# SERVICE BULLETIN

SB-AG-85

Rev E: 06/13/2025

## 510 Gallon Series Tail Spring Forward Mount Support Struts Installation

**Figure 11.1 Tail Wheel Installation Diagram**

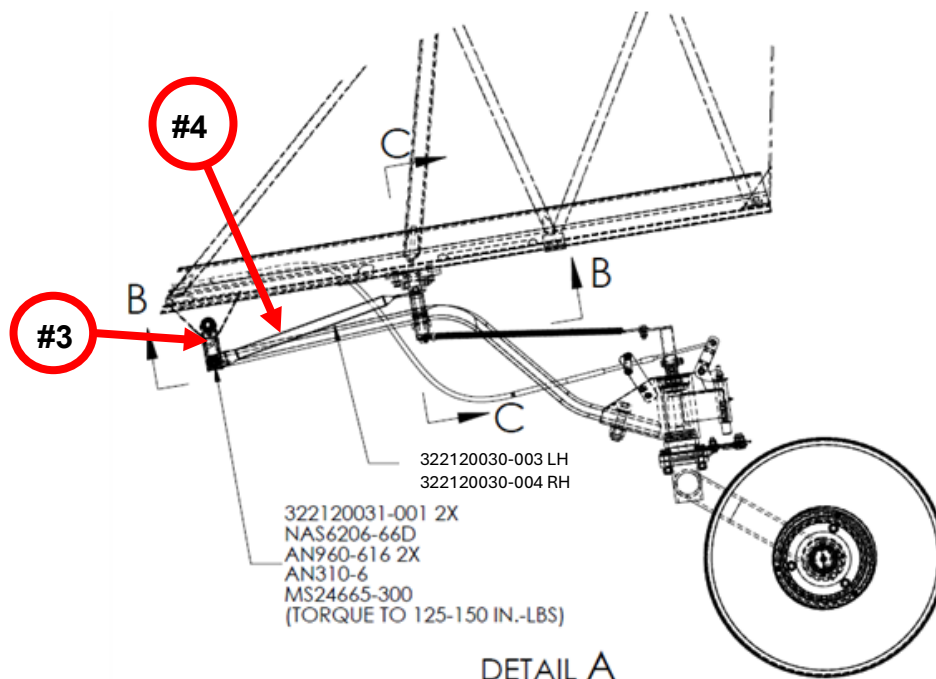
4. Locate and loosely install tail spring, struts, upper and lower support blocks and spacers, and hardware per Figures 11.1, 11.2, & 11.3.

\*\*\* Note that the position of the trunnion is not perpendicular as shown above but should be perpendicular or slightly forward when on the ground level. \*\*\*

**Figure 11.2 Tail Spring Support Blocks (Aft Mount) (View Looking Fwd)**

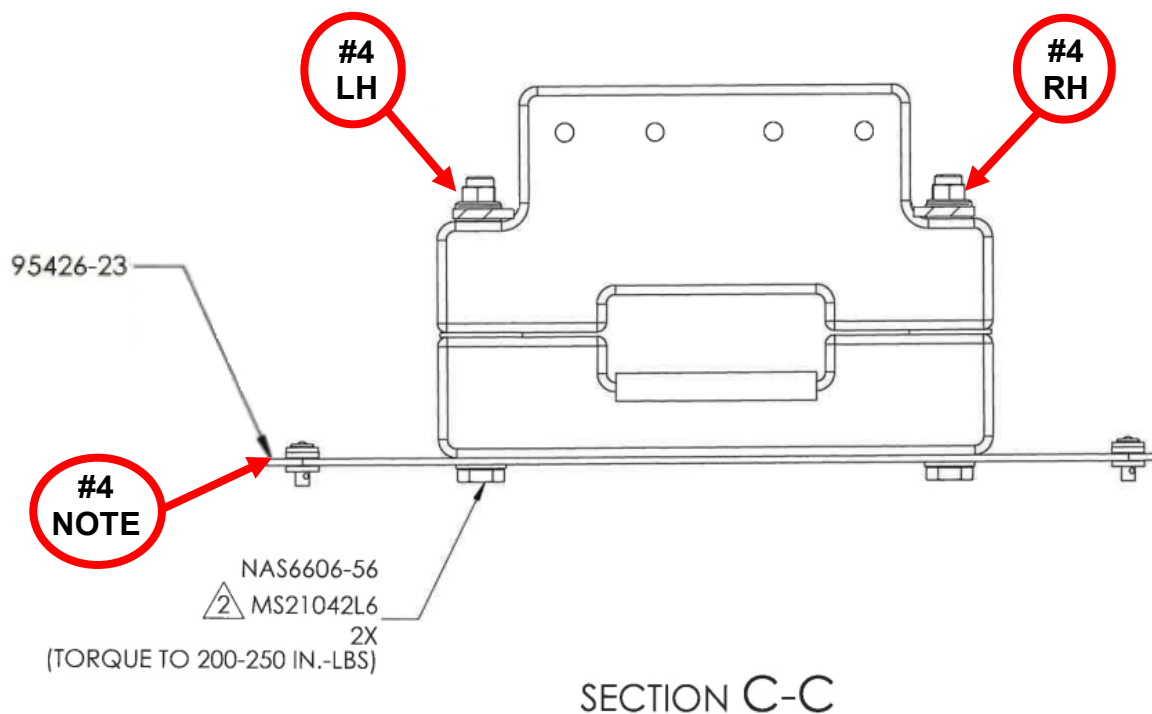
**NOTE:** At aft spacer block hardware location, install AN960C616/AN960C616L washers as necessary, any combination, 0 min – 4 max total, 2 washers maximum under bolt head or nut, to produce 1 min – 3 max thread protrusion through nut. Adjust washers as necessary to ensure no threads are in bearing.

6. Torque the two aft mount bolts (P/N: NAS6606-56) in the tail spring support blocks to 200-250 inch-pounds. (Reference Figure 11.2)

**Figure 11.3 Fwd Tail Mount Struts Installation**  
**(View Looking Up Under Belly Skin)**

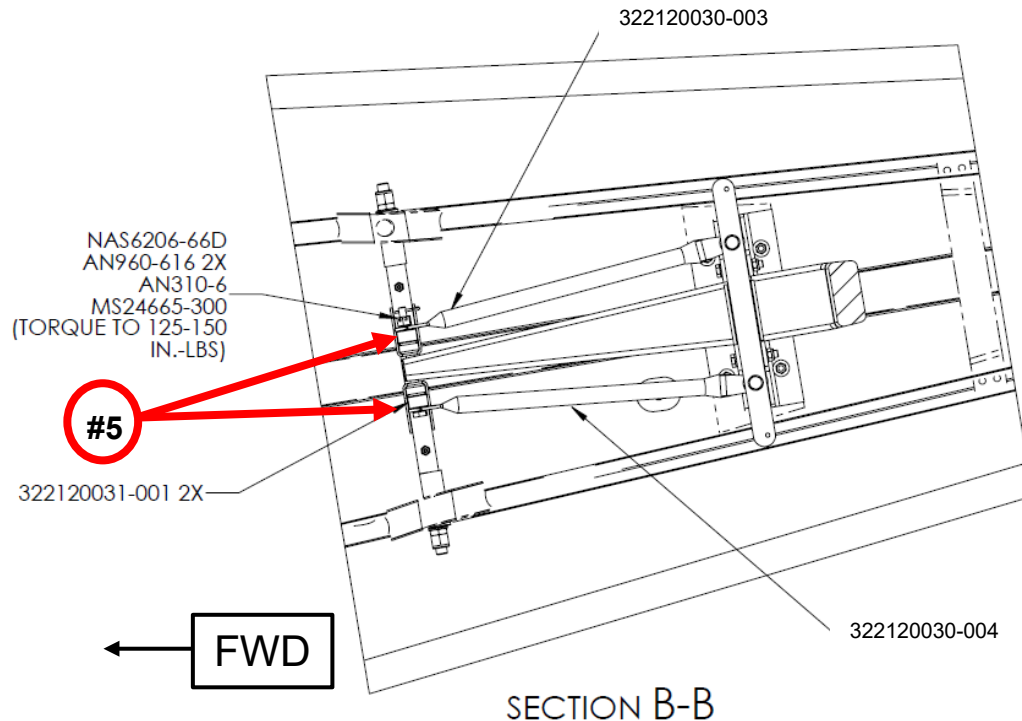
5. Torque the fwd mount bolt (P/N: NAS6206-66D) to 125-150 inch-pounds then install cotter pin. (Reference Figure 11.3)

**NOTE:** DO NOT TORQUE NUT BEYOND MAXIMUM TORQUE RANGE.  
DISCARD ANY BOLTS THAT ARE OVERTORQUED.
